NVIC NO. 8-69
22 Oct 1969

NAVIGATION AND VESSEL INSPECTION CIRCULAR NO. 8-69

Subject: Impulse-Projected Rocket Type Line-Throwing Appliances

Encl: (1) Photograph shield support bracket showing name location

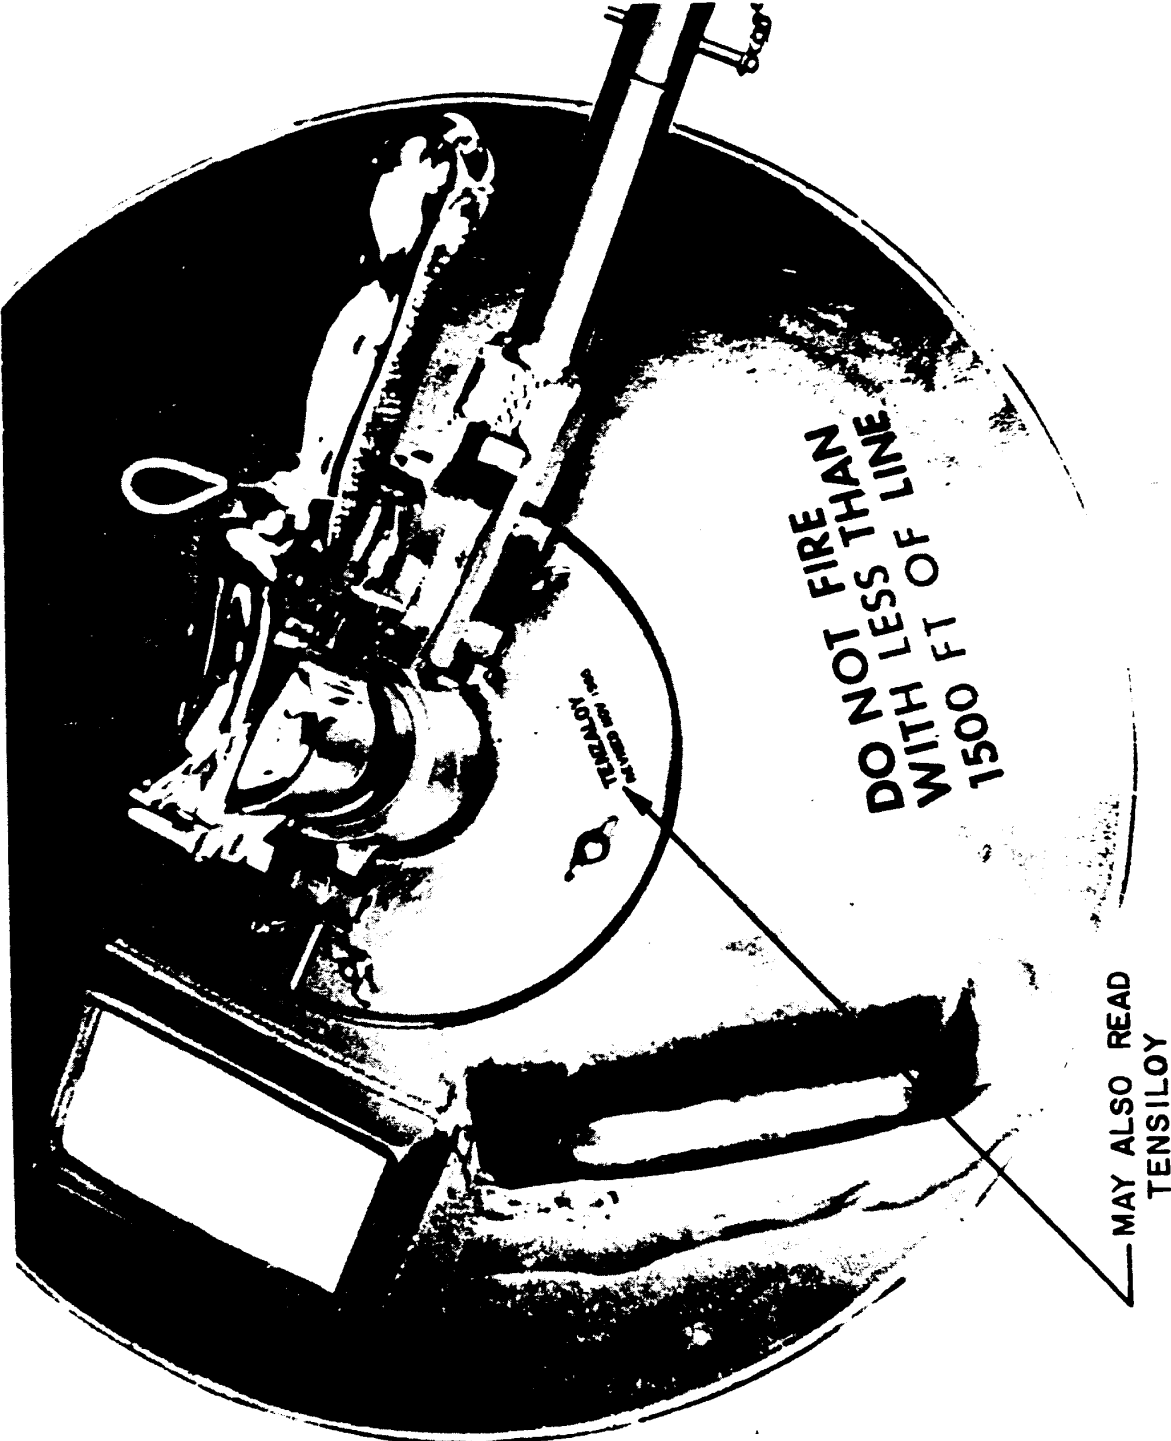
4. Action.
 - (a) All merchant vessels which carry the model G.K.-52-CK impulse projected rocket type line-throwing appliance should make certain that they have the new "TENZALOY" shield support bracket. A picture is enclosed showing where the name "TENZALOY" is placed on the bracket.

TENSILLOY

MAY ALSO READ
TENSILLOY

- (b) If it is determined that the shield support bracket is not of the new material, a replacement bracket may be ordered directly from the manufacturer, Kilgore Corp., Toone, Tennessee 383dl, at a cost of \$3.50 F.O.B., Toone, Tennessee.

- (c) When certain that the appliance has the "TENZALOY" shield support bracket, quarterly drills shall be resumed using the remote firing mode.
 - (d) The rocket propellant is of black powder composition which should not be dropped, jolted or roughly handled. The rockets should be stored so as to avoid extreme fluctuations in temperatures.
